## REMARKS

Amendments to the Drawings:

The attached sheets of drawings include changes to Figs. 6 and 20. These sheets, which includes Figs. 6-7 and Figs. 18-20, replace the original sheets including Figs. 6-7 and Figs. 18-20. Fig. 20 has been amended to show that reference character 8 is directed to a different structural element and Fig. 6 has been amended to correct reference characters.

*FIG. 6*

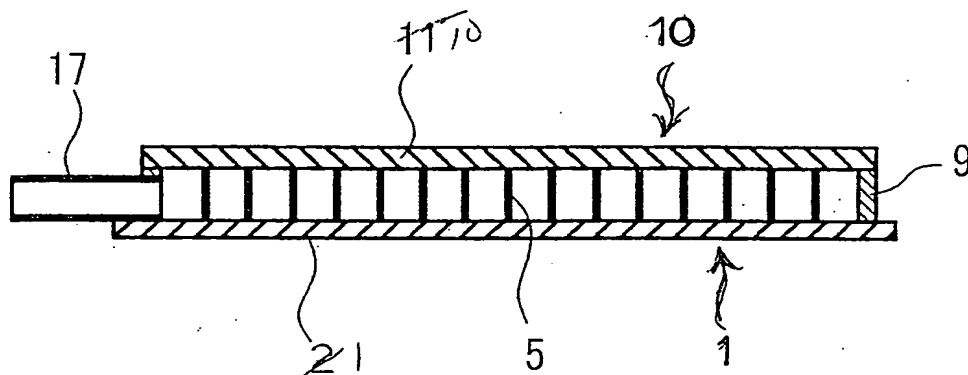
With regard to the objection to the drawings, Fig. 20 has been amended to show that reference character 8 is directed to a different structural element than reference character 6 and, further, Fig. 6 has been amended to correct reference character designations therein, with replacement sheets for Figs. 20 and 6 being presented. More particularly, Fig. 20 has been amended to show in cross-section that the branch line 8 is a separate structure from that of the control electrode line 6, and Fig. 6 has been amended to more properly show glass substrates 2 and 11 of the electron beam source panel 1 and the phosphor screen panel 10, respectively. Thus, Fig. 6, as amended, clearly shows the feature that the partition walls 5 each have one end in contact with a second panel-side surface 2 of the control electrode 7, noting that the control electrode 7 is provided on the substrate 2. As such, applicants submit that the drawing objections should now be overcome.
